Jurisdictional Concerns

Proposed Area of Coverage Based on Both Fact *and* Fiction?

Figure 1- Proposed Area of Permit Coverage

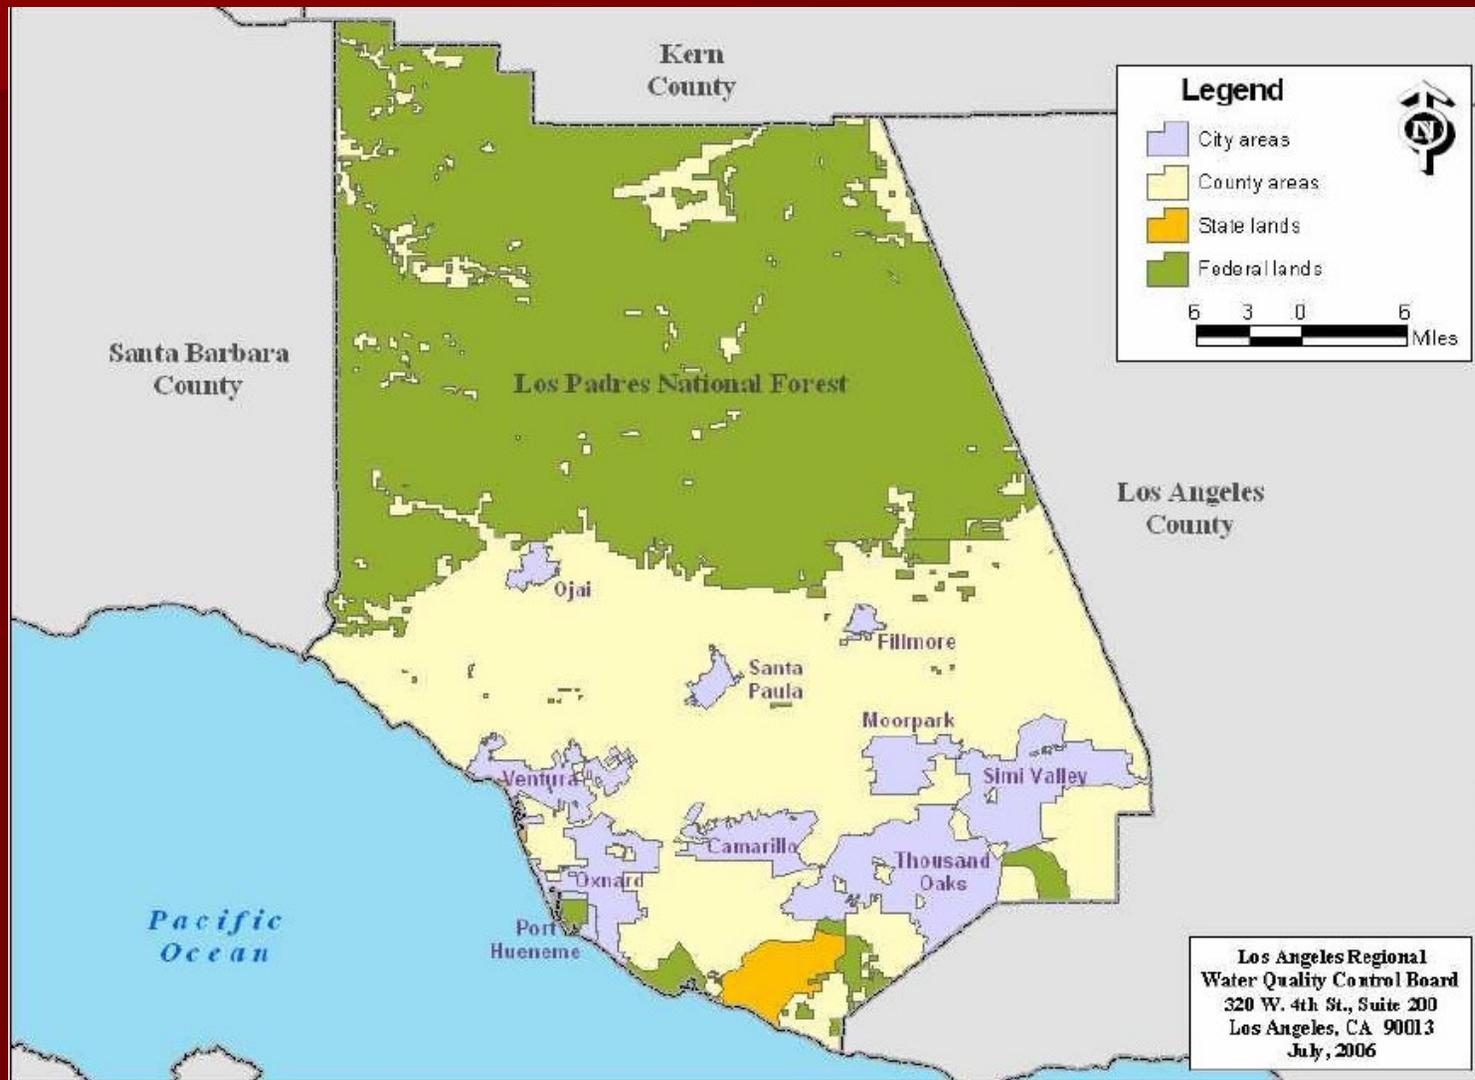
False ... **Ventura County is mostly *urban development* or area *undergoing urban development***

- MS4 Permits target runoff from *urban development*
- Unincorporated Ventura County is primarily composed of Open Space, Agricultural area, or National Forest - *not urban development*
- We urge your Regional Board to direct staff to correct an apparent *error* in the draft permit -
Please revise Figure 1 to remove all non-urbanized areas of unincorporated Ventura County from coverage under this urban stormwater permit!
